DATE: January 19, 2023
TO: Emily Meharg (City of Sandy)
FROM: Todd Prager, RCA #597, ISA Board Certified Master Arborist
RE: Tree Preservation and Removal Review for 38105 Highway 26

This memorandum is a summary of my review of the tree preservation and removal plan for the mixed-use development proposal at 38105 Highway 26 in Sandy, Oregon.

EXISTING CONDITIONS AND DEMO PLAN
MIXED USE SITE DEVELOPMENT
38015 HWY 26, SANDY, OR 97055

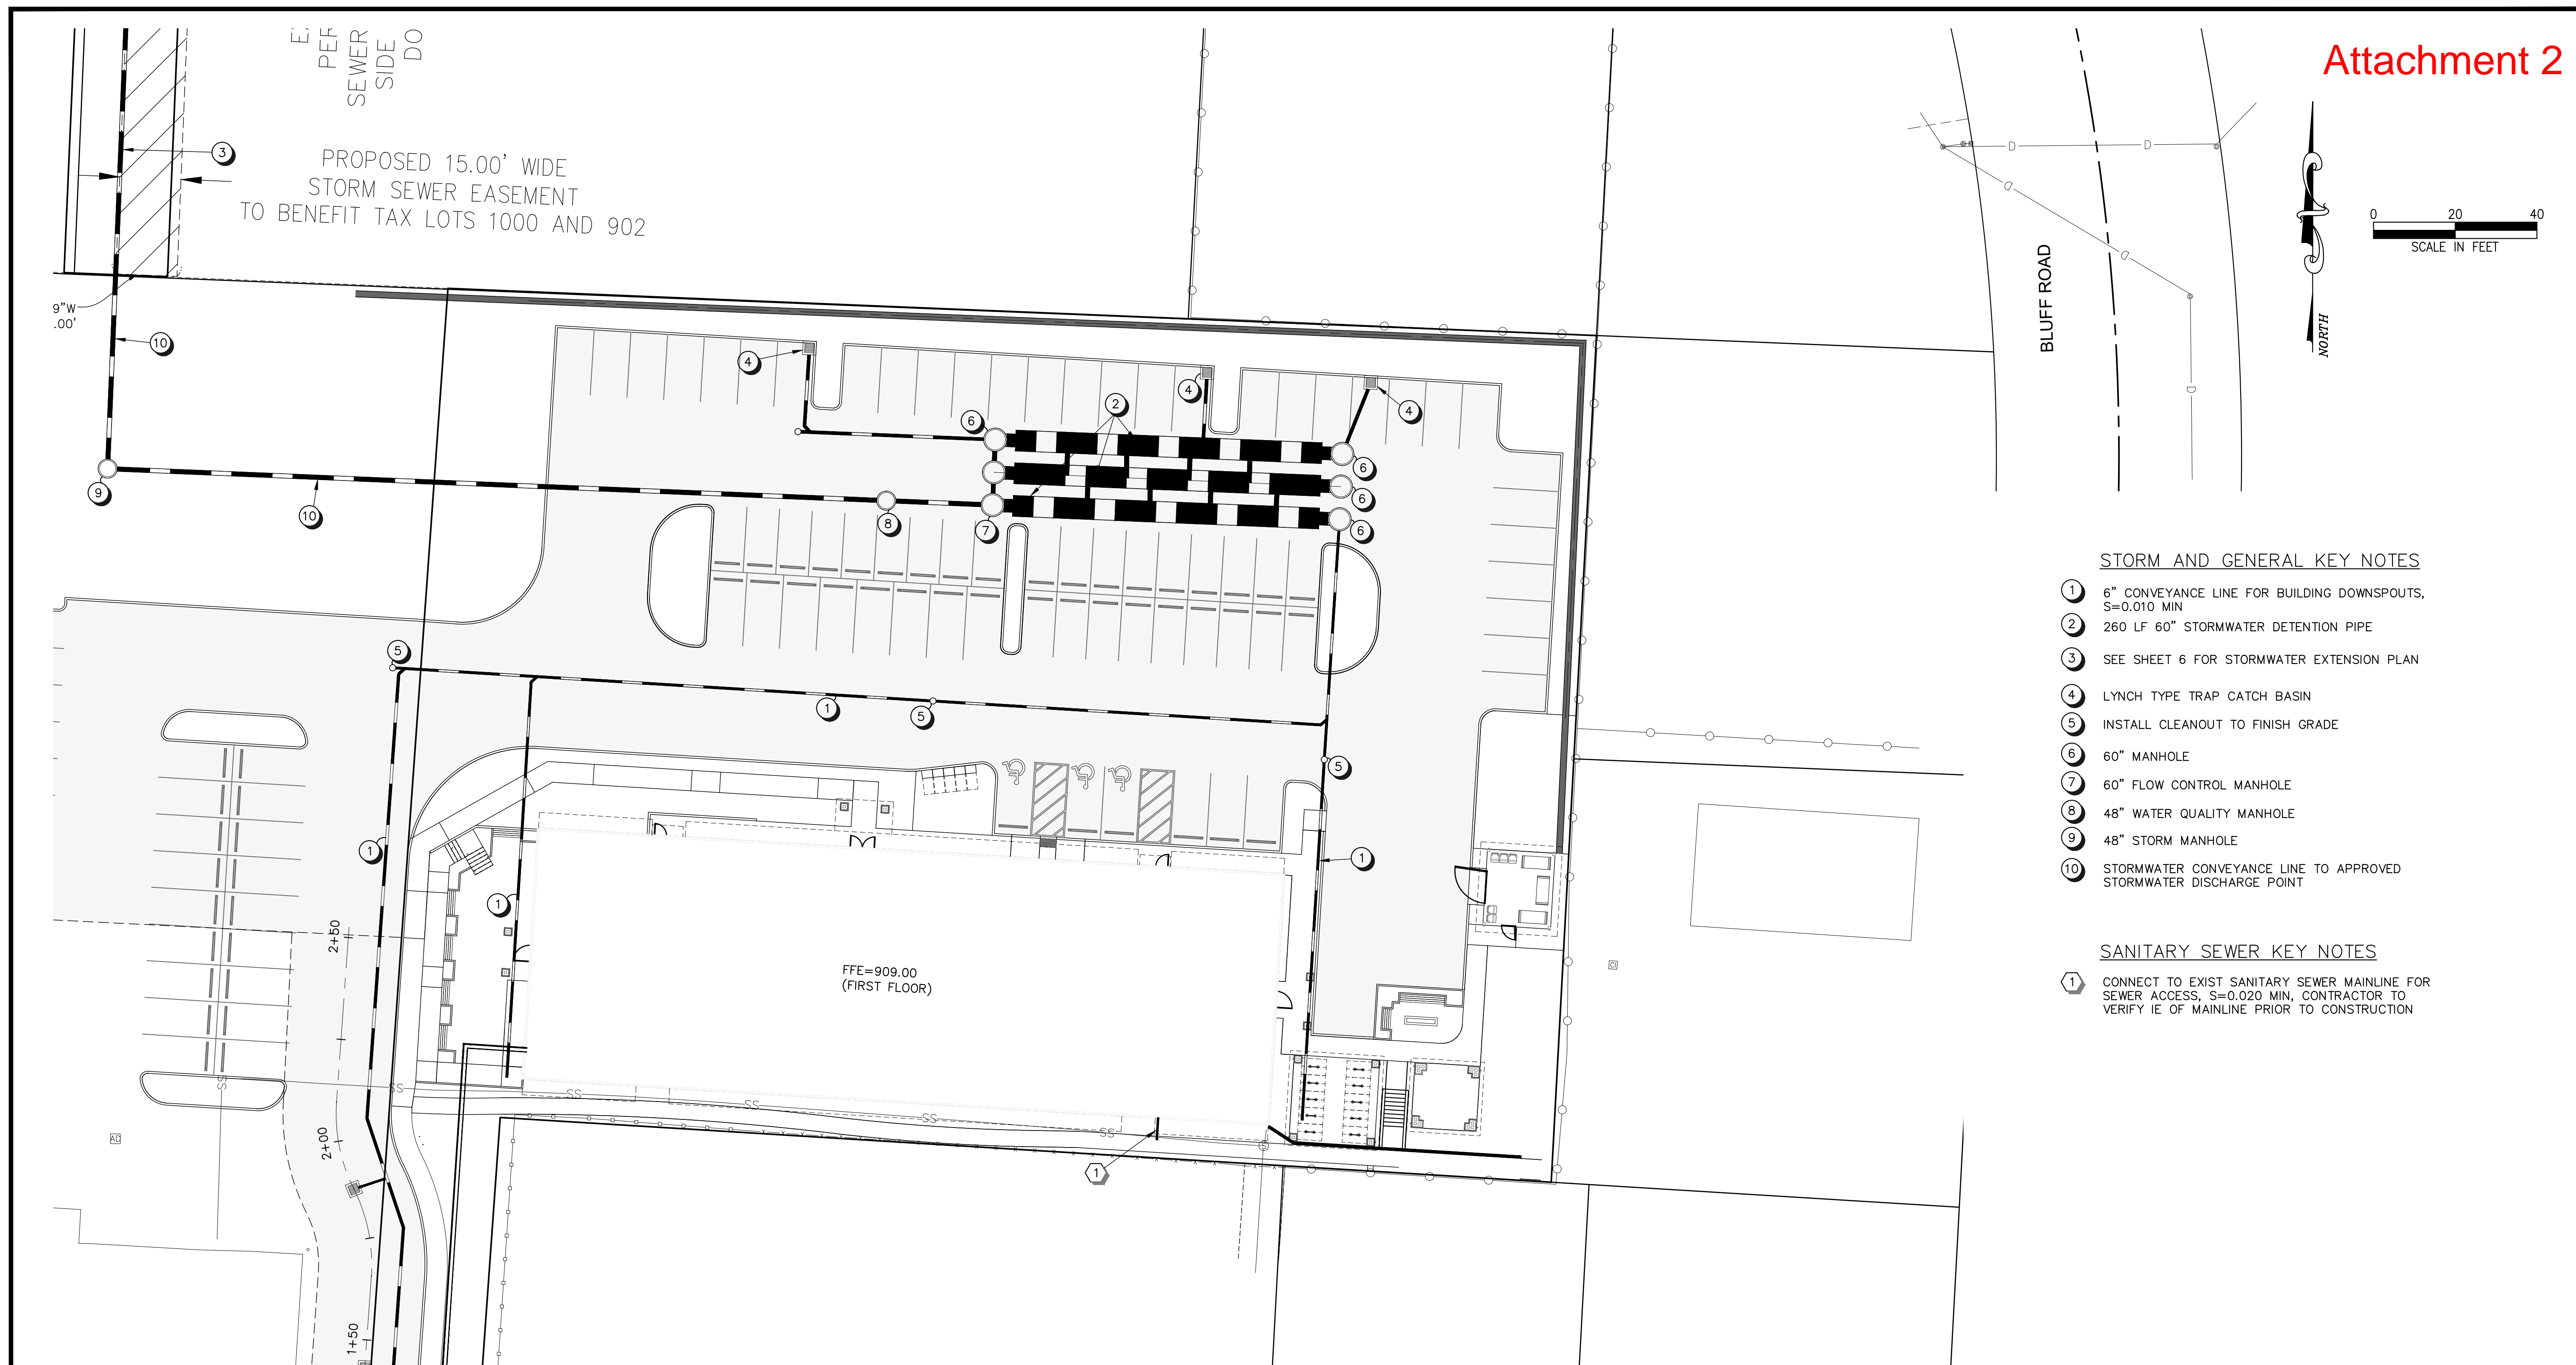
I identified 21 trees on adjacent properties that are proposed to be retained and protected with development. These trees are highlighted in green on pages 7 through 9 of the arborist report and on sheets 2, 3, and L1.1 in the plan set in Attachment 2. The City of Sandy requested my recommendations on how to minimize the negative impact to these trees on adjacent properties.

I included the typical root protection zone radii and typical minimum construction setback radii for the trees on neighboring properties to be retained on page 9 of Attachment 1 and sheets 2, 3, and L1.1 in the plan set in Attachment 2. In reviewing the proposed construction in relation to the typical minimum protection zones in Figure 1, there are 12 neighboring trees that do not meet the Figure 1 minimum tree protection zone (trees 2.1, 2.3, 13.2, 15, 21, 23, 24, 25, 26, 29, 31, and 32).

Trees 2.1, 2.3, and 13.2: Consider shifting the pedestrian pathway so it is directly adjacent to the driveway alignment at the driveway entrance adjacent to trees 2.1 and 2.3. Also, consider shifting the entire driveway further from all three trees if allowed by ODOT.

Tree 15: Consider locating utilities under the sidewalk or driveway so they are further from the tree.

GRADING AND ESC PLAN
 MIXED USE SITE DEVELOPMENT
 38015 HWY 26, SANDY, OR 97055

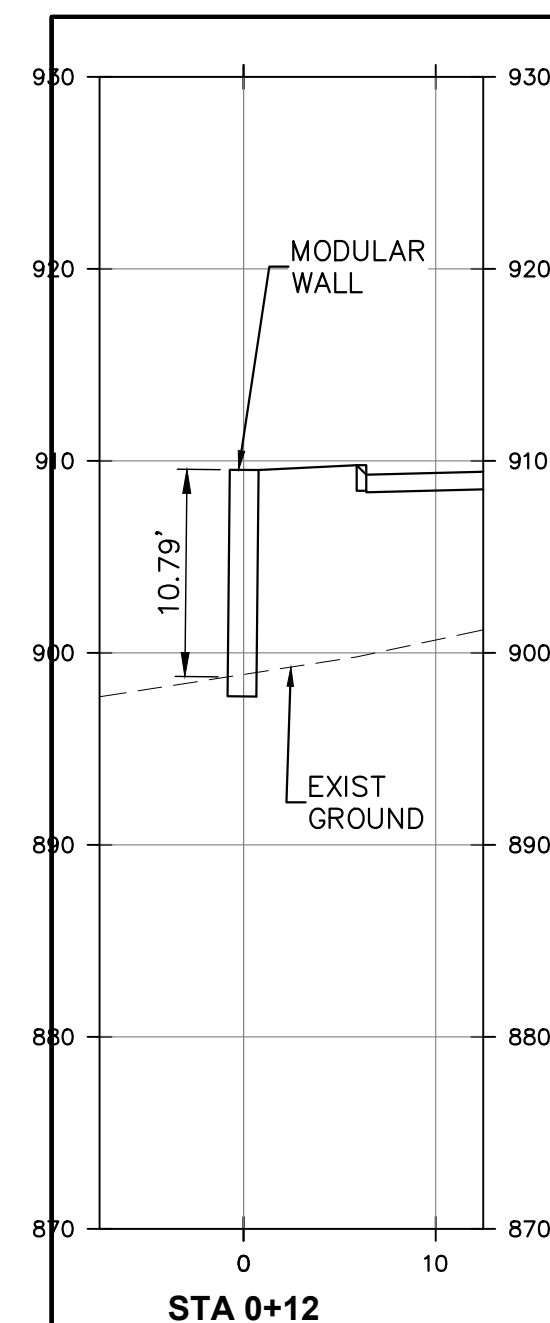
2. **Differing Site Plans:** The site plan included on page 9 of the arborist report is different from the site plans provided in the plan set in Attachment 2. The main differences appear to be on the east side of the site adjacent to trees 28 through 30. The site plan changes should be reviewed by the project arborist to ensure the trees will be adequately protected. Particular attention should be paid to the location of the proposed retaining wall adjacent to trees 31 and 32 (see sheet 3 in Attachment 2) and the proposed grading that potentially conflicts with the root zones of trees 28 and 29 (see sheet 7 in Attachment 2).

PRELIMINARY PLANTING PLAN

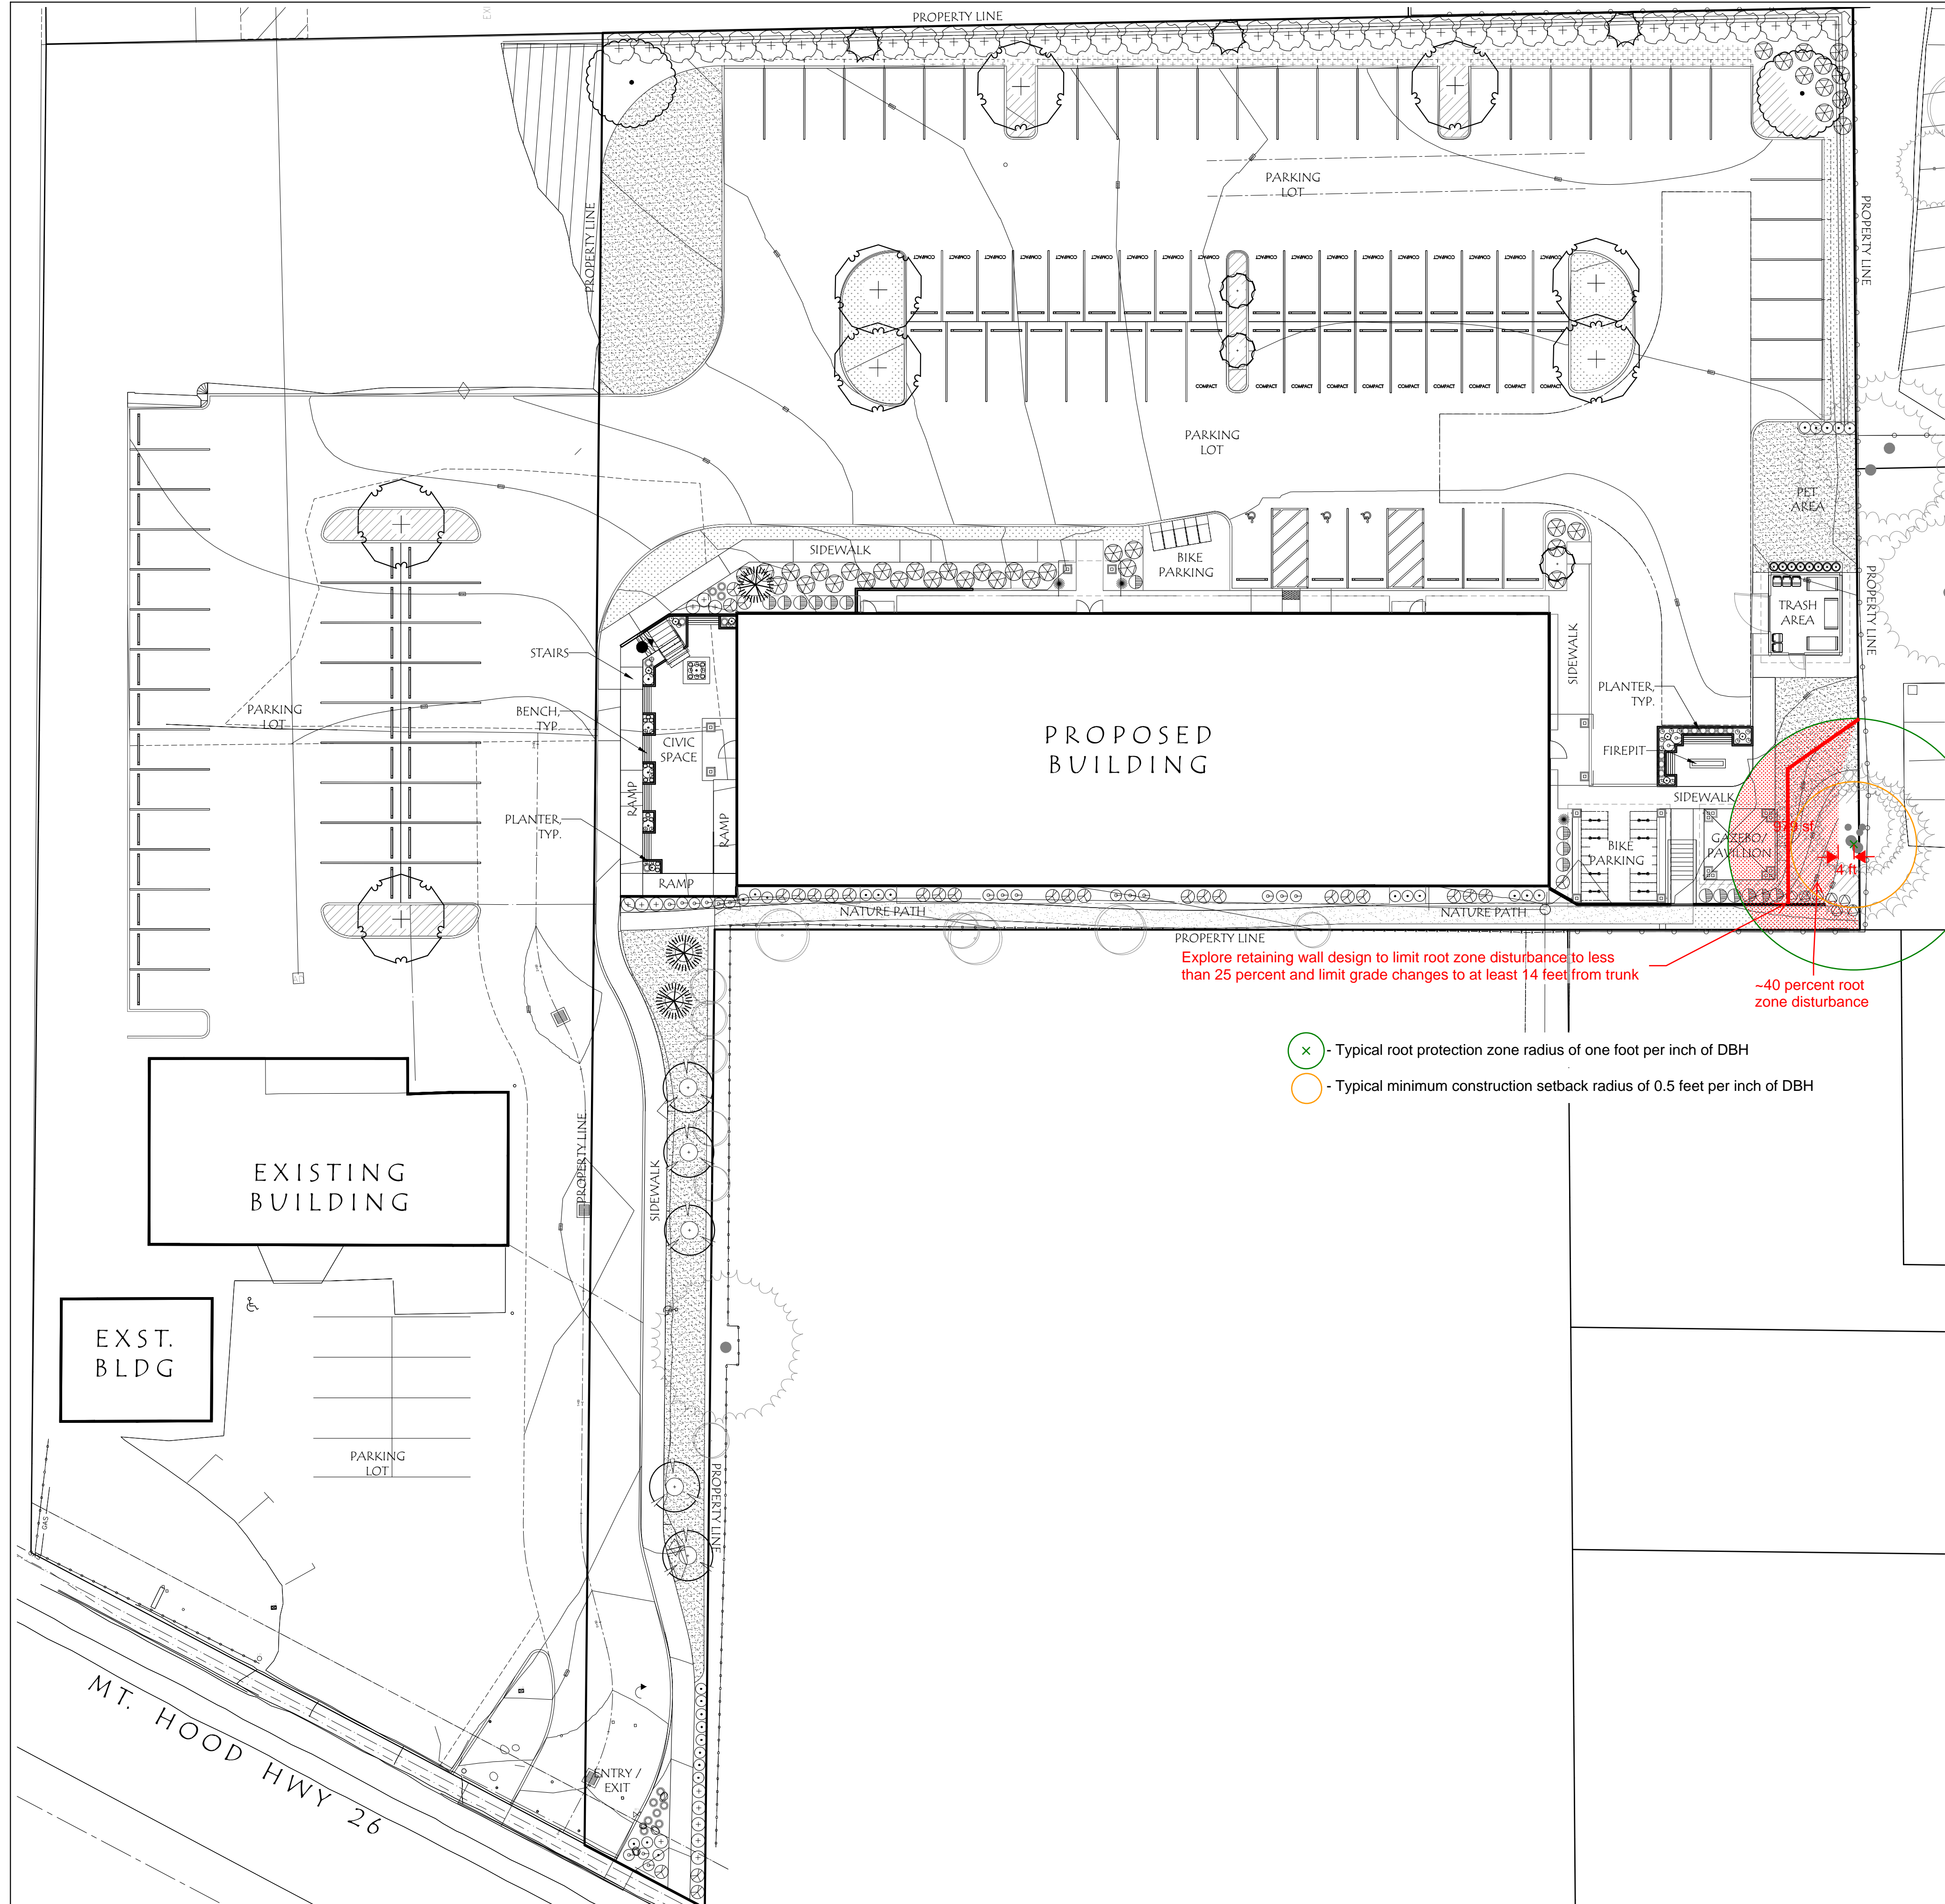
On sheet L2.1 in Attachment 2, I provided a markup of the typical root protection zone radius and typical minimum construction setback radius for tree 28. I also provided a measurement of the area of root zone impacts by the proposed construction, grading, and retaining wall in the root zone of the tree. The currently proposed impacts include grading within four feet of the tree's trunk and disturbance

of approximately 40 percent of its root zone. This well exceeds the City's typical minimum tree protection zone in Figure 1 and will likely not provide adequate protection for tree 28.

As shown on sheet L2.1 in Attachment 2, there is one black gum (*Nyssa sylvatica*) proposed in that location, which has a 20- to 30-foot-wide mature crown spread. That leaves a remaining planting space of approximately 55 to 60 linear feet. I recommend no more than one to two large, native, evergreen trees to be planted in the 1,785 square foot open lawn area to avoid excessive competition over time between trees growing in that location.

The applicant should explore whether it is possible to construct a retaining wall as shown in the example markup on sheet L2.1 in Attachment 2 to limit root zone disturbance to less than 25 percent and limit grade changes and any construction to at least 14 feet from tree 28. If this is possible, the tree could be adequately protected.
